**Overview:** Production error in version 1.0 harnesses; The immobilizer wire (orange/black) is in pin position #4 instead of pin position #5. Although an effort to correct the issue was made, some quantity of harnesses did get shipped before the issue was spotted. We are advising to inspect the harness BLADE connector before attempting to install harness or program the module. This issue is not known to affect the version 2 harnesses, which require no modification.

**Overview:** Early versions of the FTI-STP1 harness require modification for **automatic transmission (AT)** applications, some of the product was able to be modified before release, but a small quantity was released without modification.

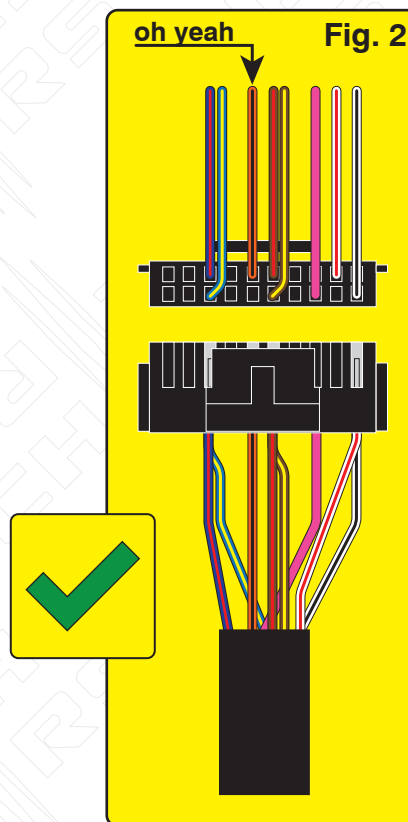
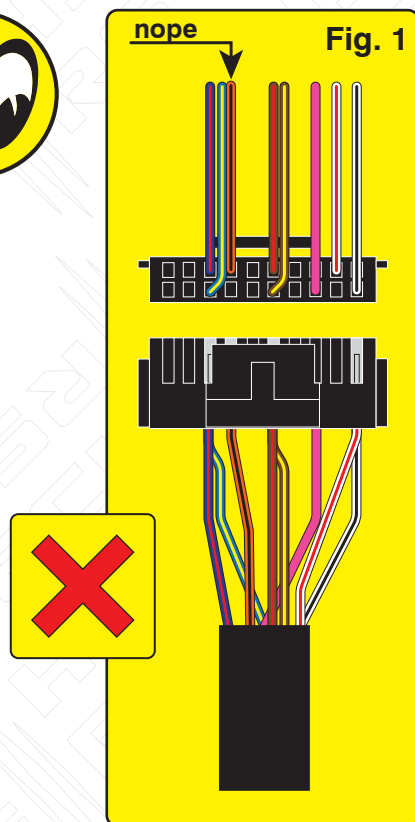
**Issue:** Module fails to program correctly to vehicle, does not allow the vehicle to be remote started.

**Correction:** Step 1.) Locate the orange/black wire and confirm whether it is positioned as illustrated in Fig. 1 or Fig. 2. If the wire is as illustrated in Fig.1, proceed with Step 2 through 5 and complete the repair procedure outlined, if the wire is as illustrated in Fig. 2, correction is not necessary, proceed with harness installation and module programming.

**Step 2.)** Using a pick, lightly depress the catch that secures the terminal in the housing then remove the wire and terminal from the housing.

**Step 3.)** Using a fine tip razor or utility knife, insert the blade beneath the terminal catch and raise it slightly, so that it can be reused to secure the terminal when reinserted into the BLADE connector housing.

**Step 4.)** Refer to Fig. 2 for correct position of the orange/black wire (next to brown/red) then reinsert the terminal, pressing lightly until the catch 'snaps' into place, securing the terminal in the connector housing.

## MODIFICATION REQUIRED FOR A/T APPLICATIONS, ONLY WITH v 1.0 HARNESS

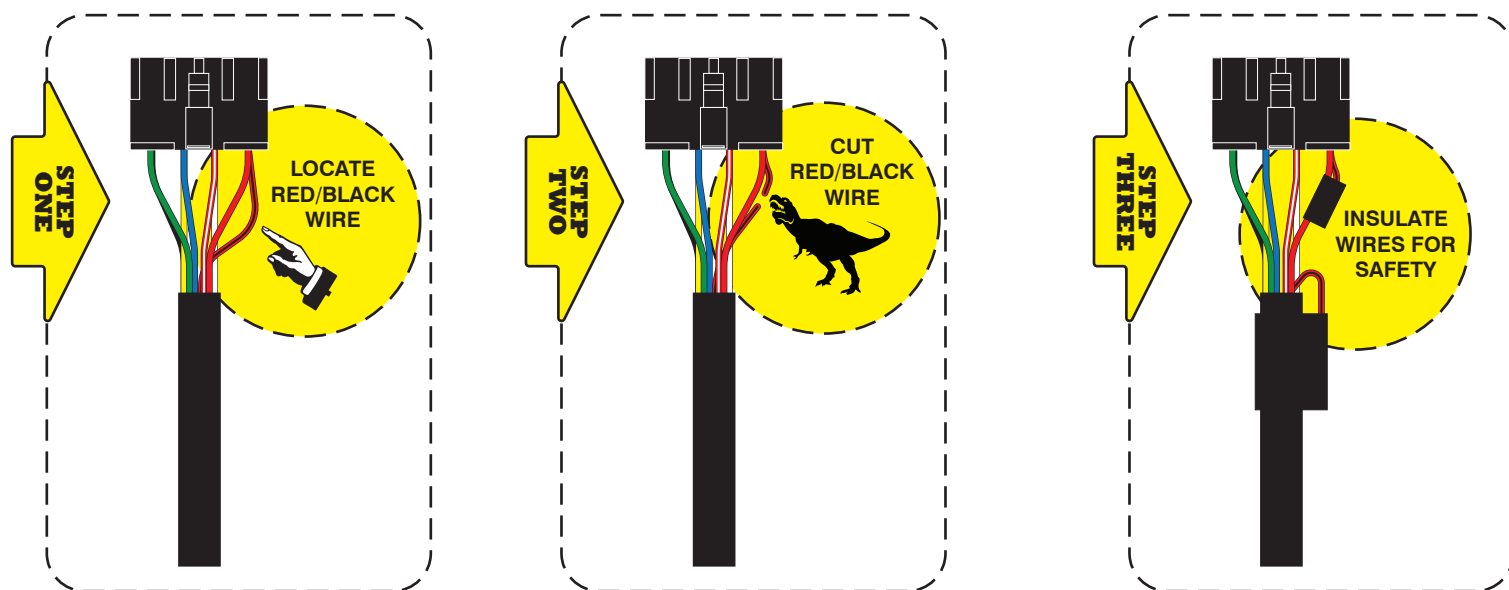
**Issue:** The FTI-STP1 T-harness has been designed to be compatible with A/T (automatic transmission) & M/T (manual transmission) applications, but due to an oversight in early production runs, the selection was defaulted to M/T mode.

Using a harness configured for an M/T application, in an A/T equipped vehicle, could result in vehicle module damage, it is advised that the harness be returned to A/T mode before installation in vehicles equipped with an automatic transmission.

**Correction:** Locate the **red/black (+ Clutch)** wire provided in the CN1 connector of the main harness assembly. Cut the **red/black** wire, either flush to the CN1 connector, or leaving enough wire exposed so that you can insulate and secure the ends of the wire that remain after cutting. Insulate each of the remaining ends of the **red/black** wire and secure to prevent any possibility of a short circuit. **If the red/black wire has already been disconnected, no further modification is required for A/T applications**
